ADDENDUM

Project: Grand Lake St. Mary's State Park, Park Office Renovation
Project No.: DNR-250013
Date: October 21, 2025
Addendum No.: 1

E200.1

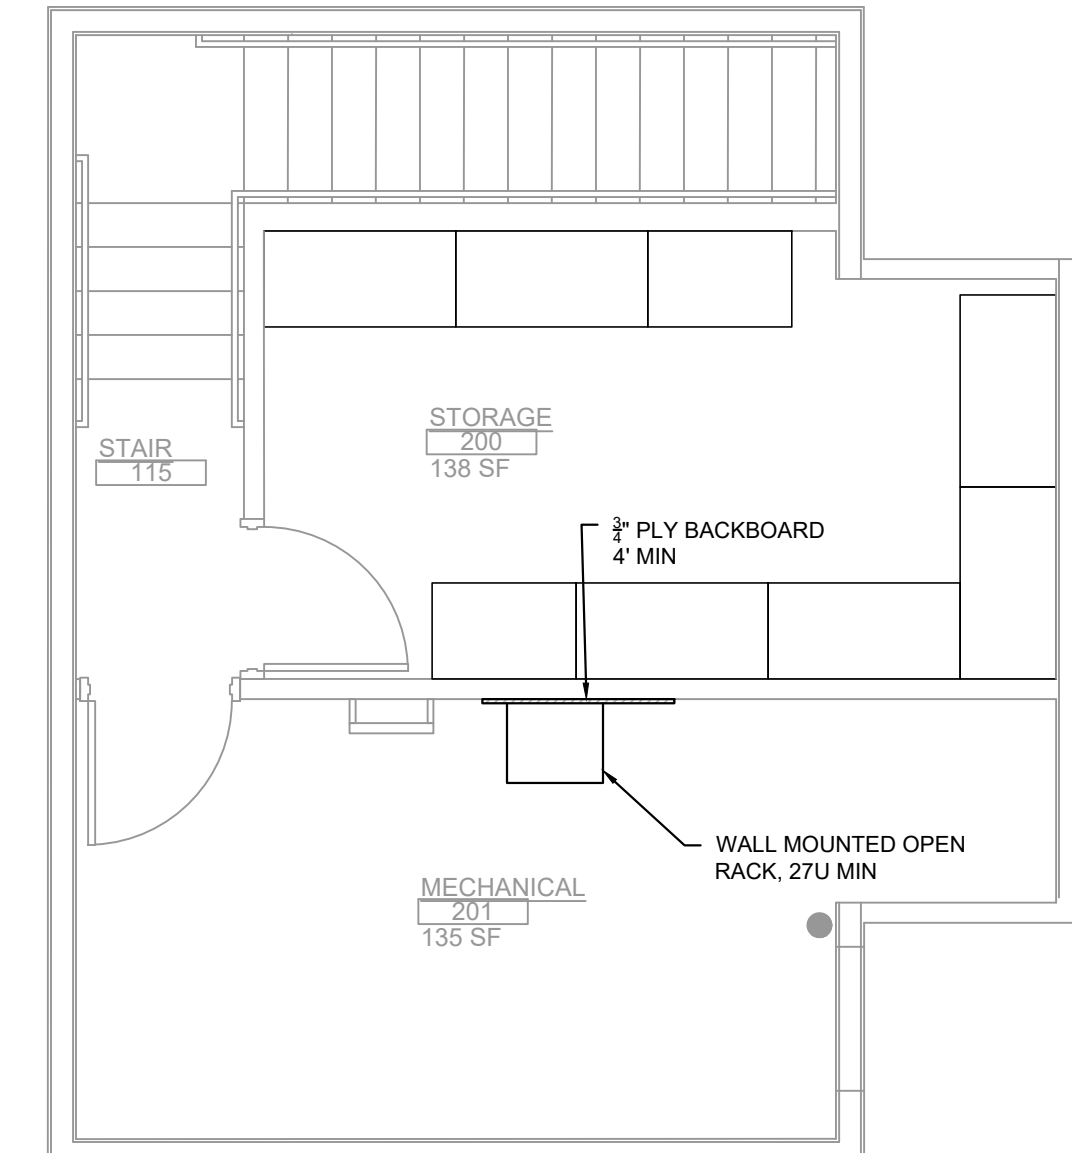
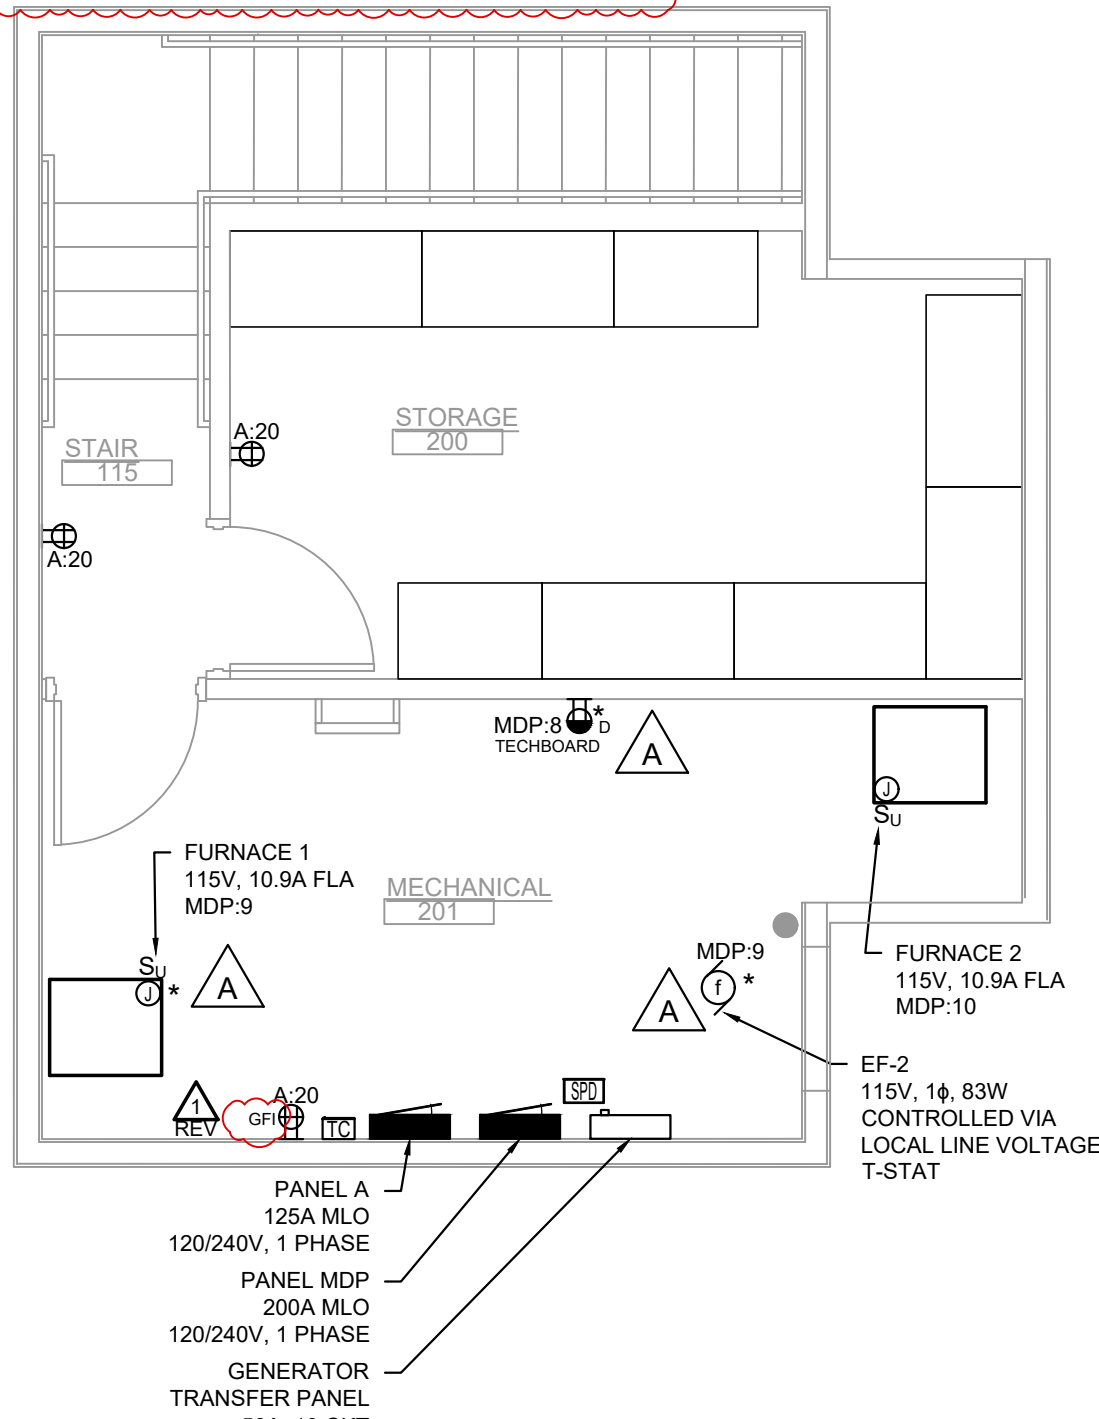
Item 12 – E200.1 (Revised)

- Eliminate the generator connection to match the existing connection. Instead provide a new 50A generator inlet connection and a new generator connection cord.
- Battery option has been added to light fixture “F”. See revised sheet E100.1.
- Circuit A-2 serves a dedicated microwave outlet inside a kitchen cupboard. Outlet has been revised to GFI. Circuit A-12, MDP-13, and various other circuits have GFI protection at the breaker. This is indicated in the panel schedule with a “G” next to the amperage rating of the breaker. The outlet next to the electrical panels has been revised to a GFI outlet. See revised sheet E200.1

- A. Provide a 50A inlet receptacle: Qty. (1) for emergency power rated at 50 amperes, shall be NEMA 3R, clamshell design with gaskets, 120/240v, 1Φ, corrosion resistant metallic box or non-metallic box.
- B. Must have an indicator light for a successful connection.
- C. Inlet receptacle shall be tested and labeled by the Underwriters Laboratories.

- A. Provide a replacement cord for the existing generator.
- B. Must be a minimum of 20', with and be exterior rated, SOOW cable.
- C. Cord must have a 50A plug on both ends, NEMA 14-50P. Contractor to verify with existing equipment prior to work.

12. KEEP ALL UTILITIES TIGHT TO THE WALL IN THE PLUMBING CHASE OF JANITOR ROOM 105.
13. THE CONTRACTOR SHALL PROVIDE A NEW 20-FOOT GENERATOR CONNECTION CORD EQUIPPED WITH A NEMA 14-50P PLUG ON BOTH ENDS. PRIOR TO WORK, VERIFY COMPATIBILITY WITH EXISTING EQUIPMENT. REFER TO THE APPLICABLE SPECIFICATION SECTION FOR DETAILED REQUIREMENTS.

E300.1

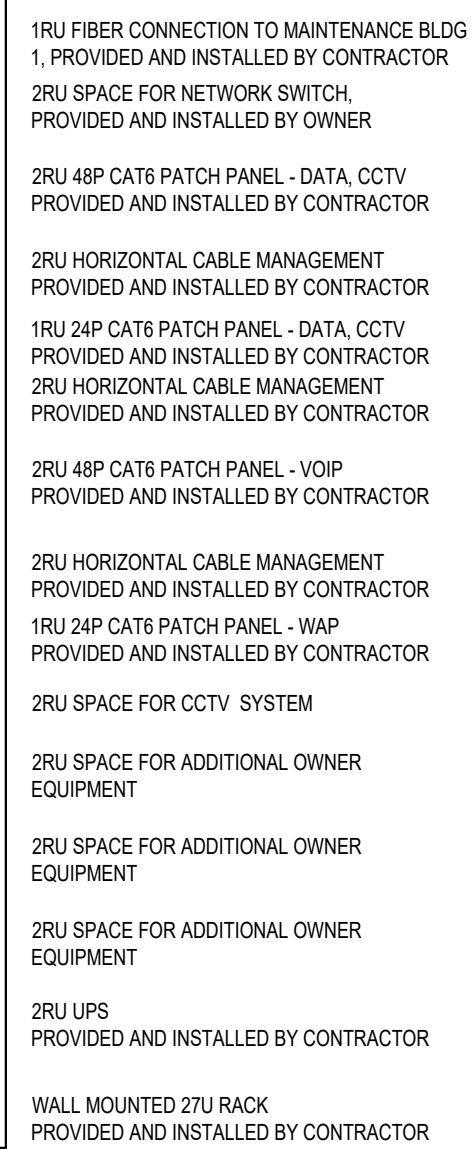
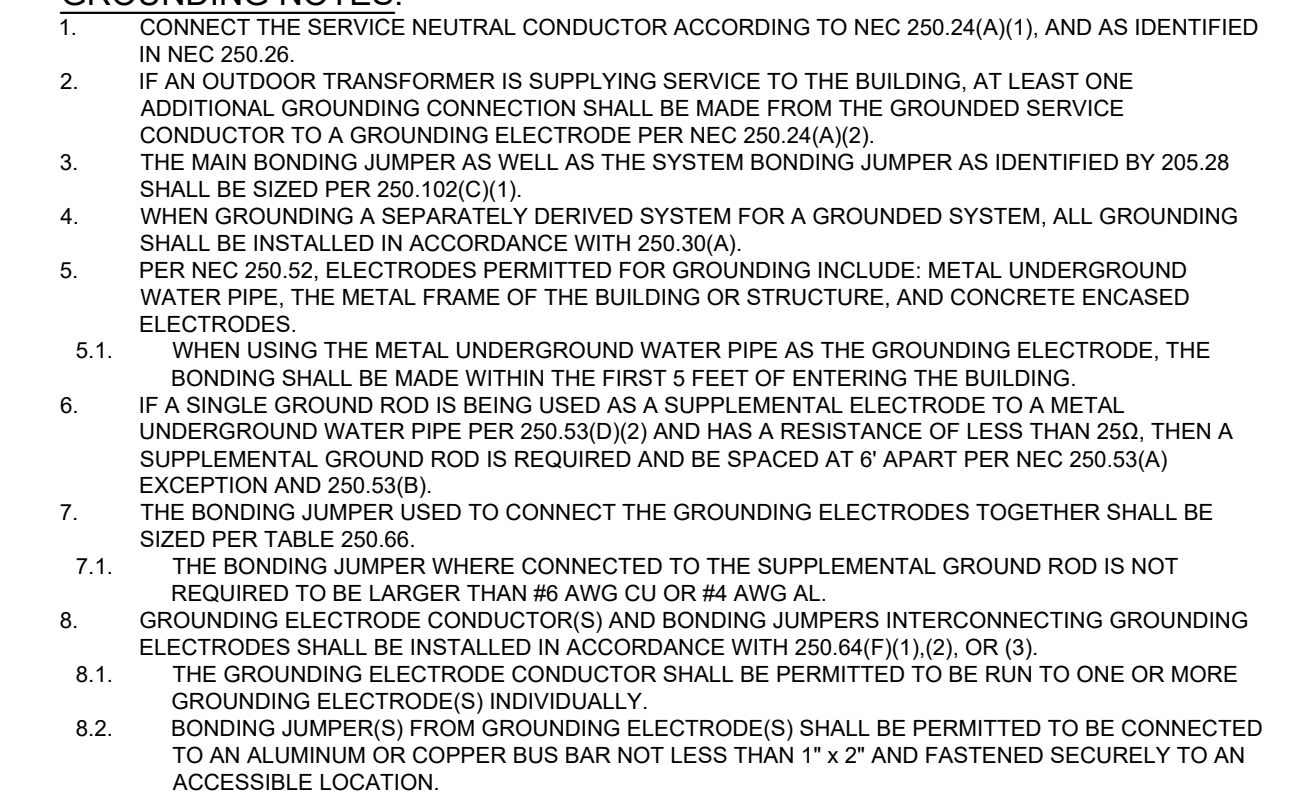
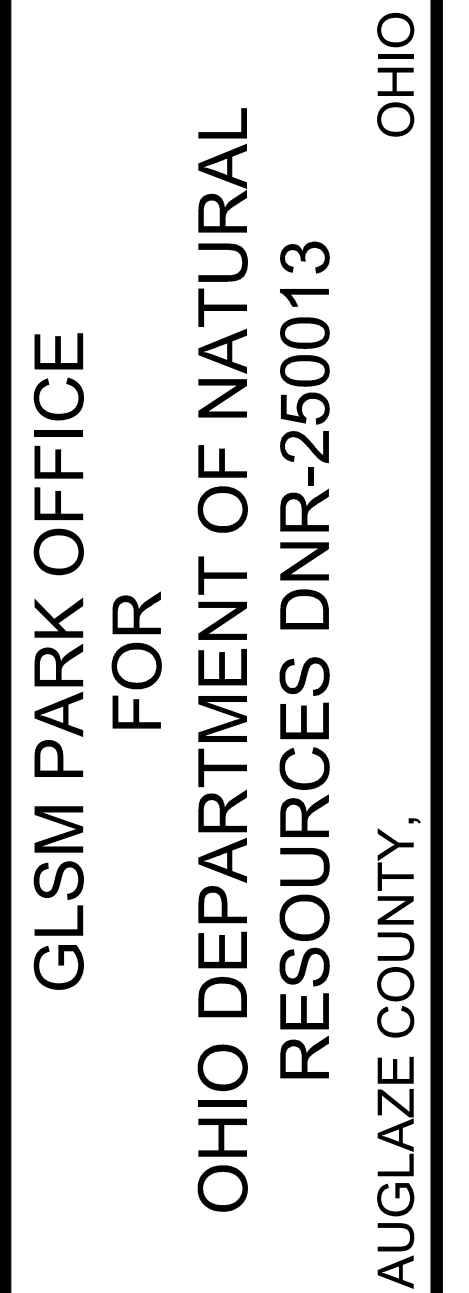
Item 13 – E300.1 & E300.2 (Revised)

- Modify data locations per CD submission comments
